U. S. NUCLEAR REGULATORY COMMISSION
REGION I

DOCKET/REPORT NOS: 50-293/95-27
LICENSEE: Boston Edison Company (BECO)
FACILITY: Pilgrim Nuclear Power Station
LOCATED AT: Plymouth, Massachusetts
EXAMINATION DATES: November 22-December 1, 1995
EXAMINERS: D. Florek, Senior Operations Engineer
J. Caruso, Operations Engineer
K. Kolaczyk, Operations Engineer

Examination Report 50-293/95-27 (OL)

PNPS	Emergency Plan Implementing Procedure Manual	Number: EP-IP-100
	Title: Emergency Classification	Revision: 7

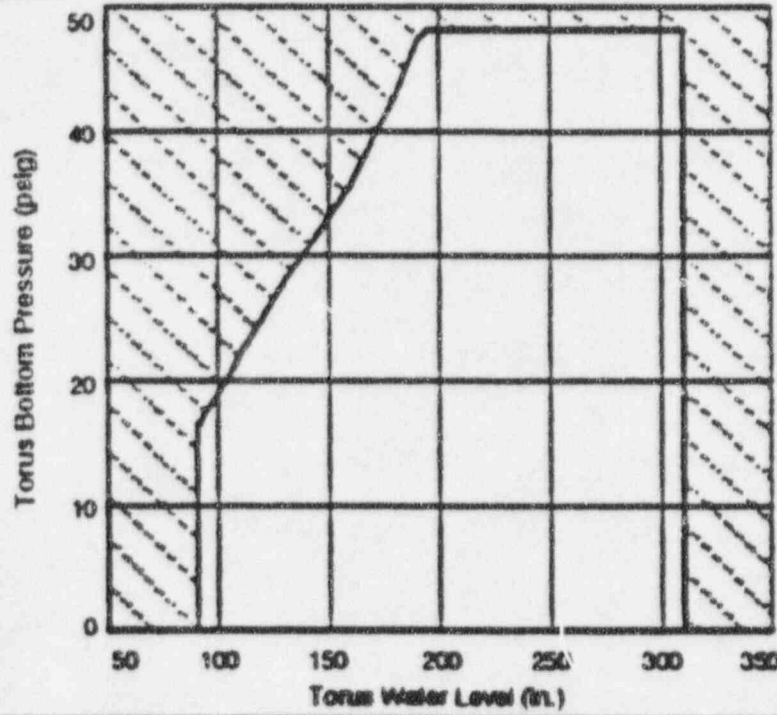
'C' IS THE CORRECT ANSWER BASED ON THE INFORMATION PROVIDED AND FIGURE 6, PRESSURE SUPPRESSION PRESSURE (PSP) CURVE OF THE EOP'S. HOWEVER FIG. 6 WAS NOT PROVIDED TO THE CANDIDATES.

'B' IS A CORRECT ANSWER BASED SOLELY ON THE INFORMATION PROVIDED

C AND B ARE BOTH CORRECT
SEE ATTACHED.
